# REVIEW COMMENTS

**TITLE HEADING:** Site Plan Review - Reynolds  
Polymer Technology

**LOCATION:** 607 Hollingsworth

REVIEW COMMENTS  
ON  
REYNOLDS POLYMER TECHNOLOGY, INC.  
5/19/93

LANDSCAPE PLAN  
 1" = 40'-0"

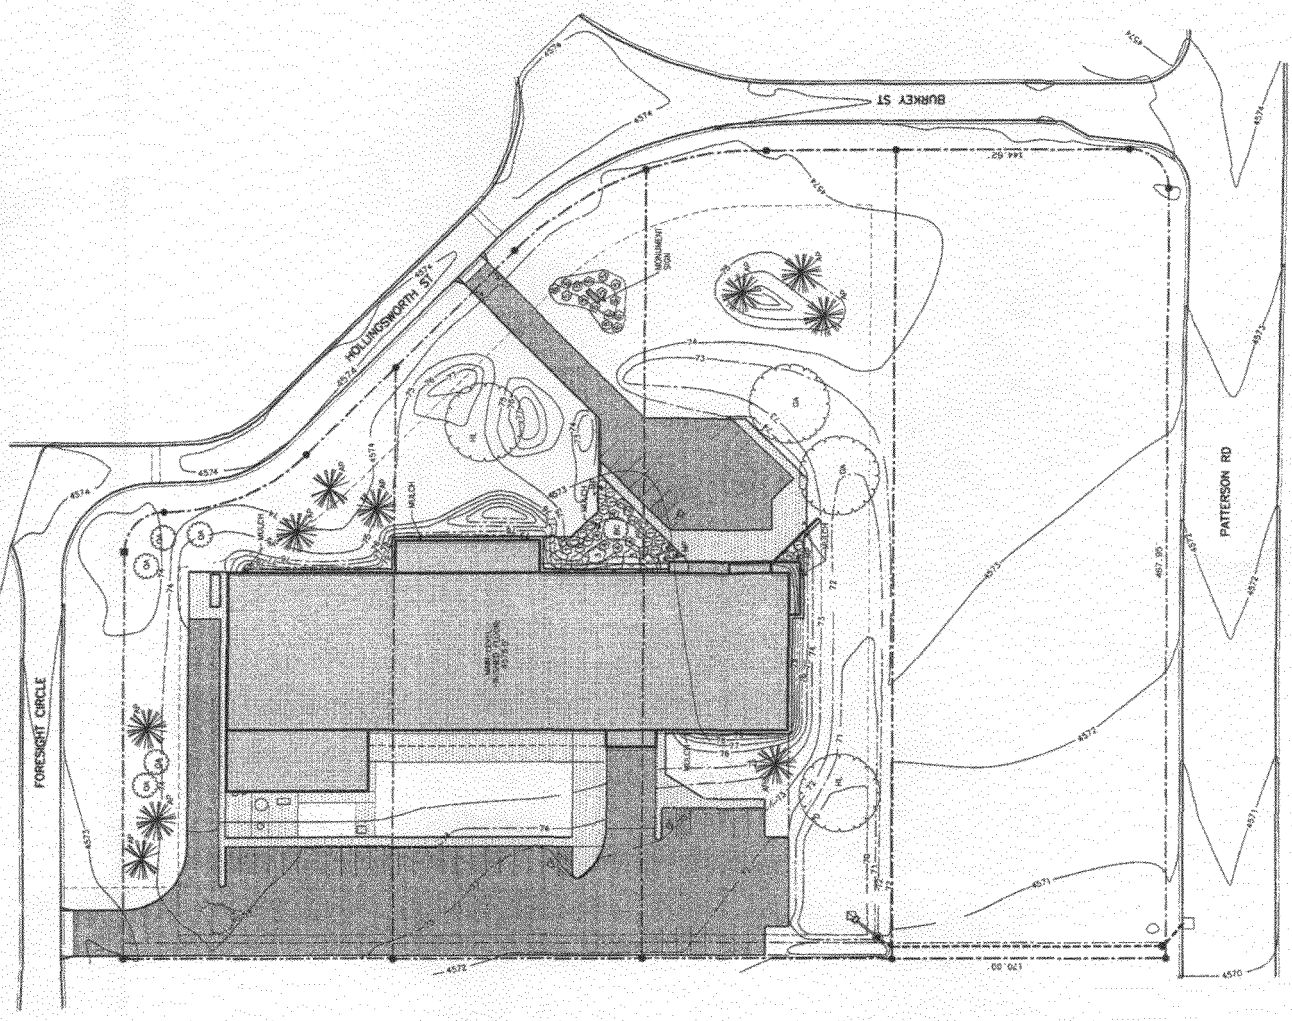
Along north side, Austrian pines need to spaced apart more. Along northeast side, Austrian pines closest to building need to be removed; same with southwest side. Replace with a dwarf shrub or if you want to keep a "tree type" at these location, replace with the Bechtel crab tree. Want to eliminate hiding places near building and also want to increase visibility of the building for patrol drive-bys. What type of lighting is proposed for the parking lot and for the exterior of the building? recommend an exterior type light over every access door. What type of exterior doors are you proposing? Is the address to the building going to be visible from the street? Also - do not use Mugo Pines near building, instead use a low ground cover juniper; example: Arcadia Juniper or Buffalo Juniper.

**1 GRADING AND DRAINAGE PLAN**  
 1" = 40'-0"  
 EXISTING CONTOUR: 4575  
 NEW CONTOUR: 4575  
 SPOT ELEVATION: 4570.3

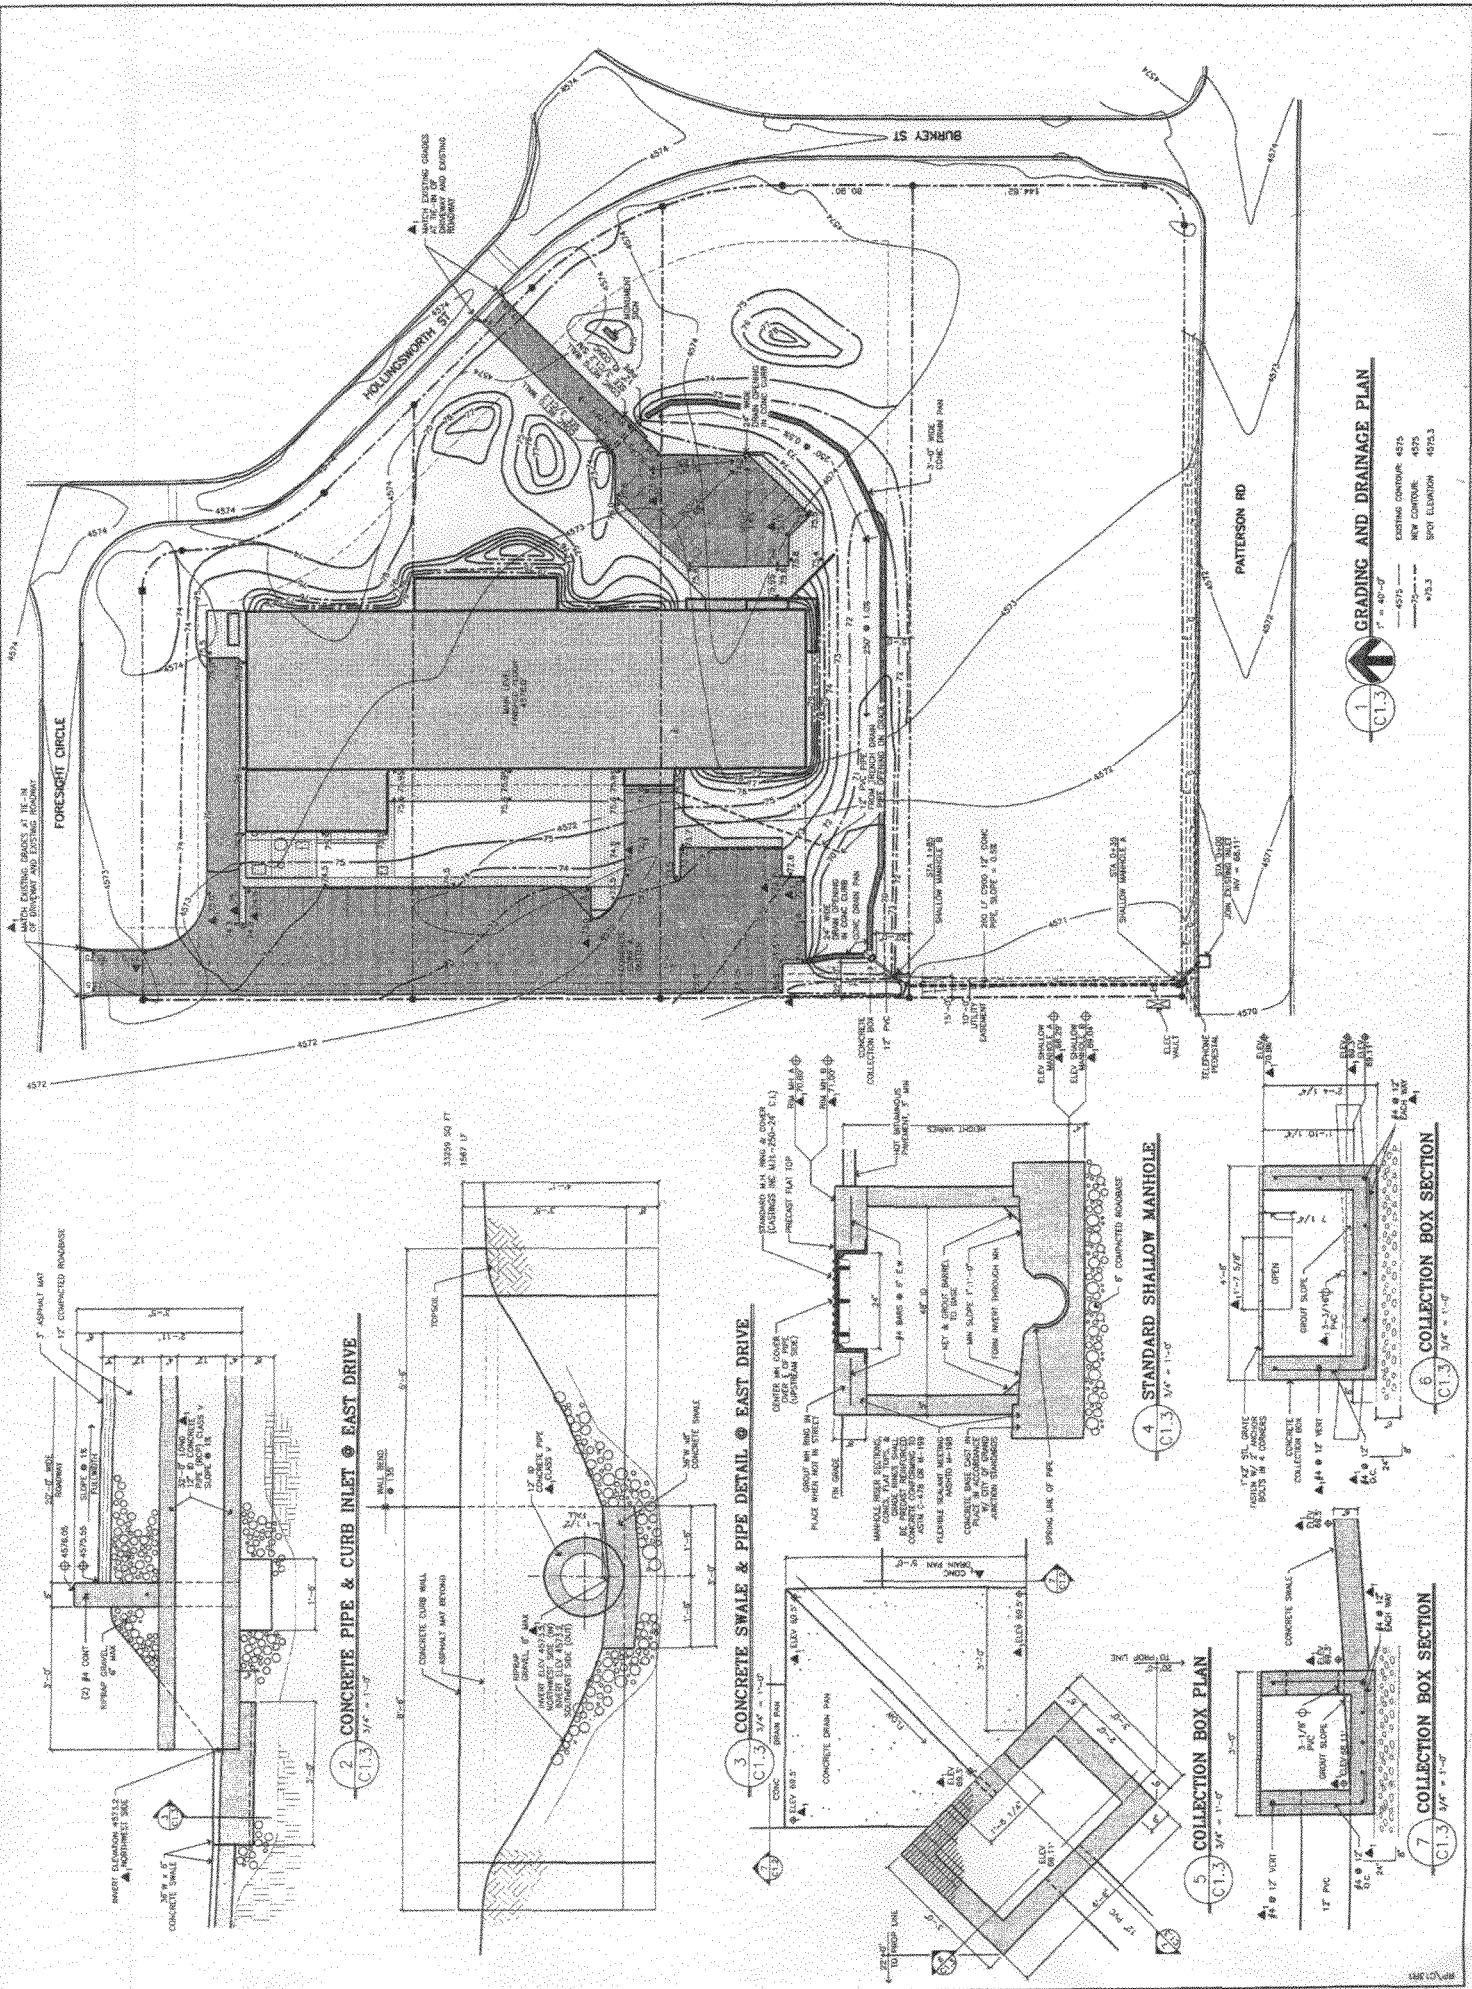
1. A few elevations are missing as noted on the attached plans. These must be provided, along with slopes, grade breaks, swales, etc.
2. Is erosion protection provided at the west entrance to the detention pond?

3. The pond bottom is too flat! Criteria requires a minimum of 2% to prevent bogs from irrigation water, although 1% may be acceptable. However, less than 0.6% is provided on the east side, and the main basin is flat, with no slope at all to the outlet. The volume provided may be more than adequate to meet drainage requirements, and slopes could be somewhat steeper.

4. Manhole rim elevations and invert elevations must be provided.
5. Show in plan view all utilities parallel, crossing, and near the proposed basin drain pipe. Provide a profile of the line, showing all conflicting utilities. With the information given, the pipe slope appears to be 0.5%, not 1.0%. The 12 inch pipe would still be adequate.

6. The trench drain outlet pipe lacks invert, cover, and pipe class information. It also appears that it will be very flat. Will it work?
7. What class of pipe shall the concrete culvert be? It has only 1.0 foot of finish cover, and much less during construction. Also, what are the invert elevations?

**SITE PLAN**  
 1/4" = 1'-0"

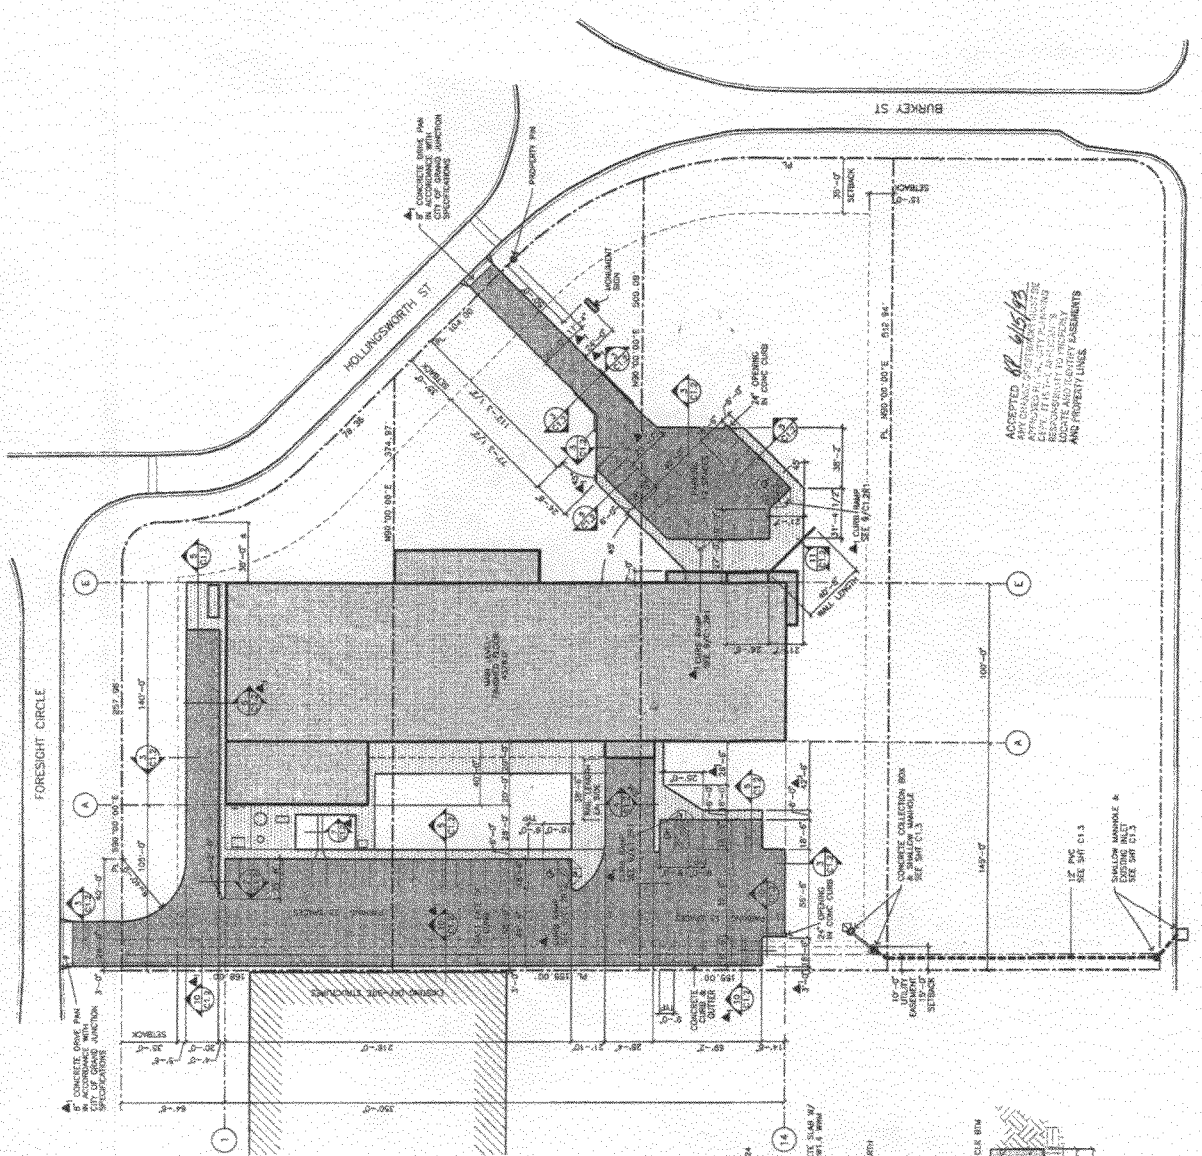
1. Driveways must be 8" thick per City Standards, not 6".
2. Per City Code, a minimum of 25 feet traffic area is required behind 90° parking. The east parking lot does not conform.
3. Some of the section views are incorrect in location or direction of view.
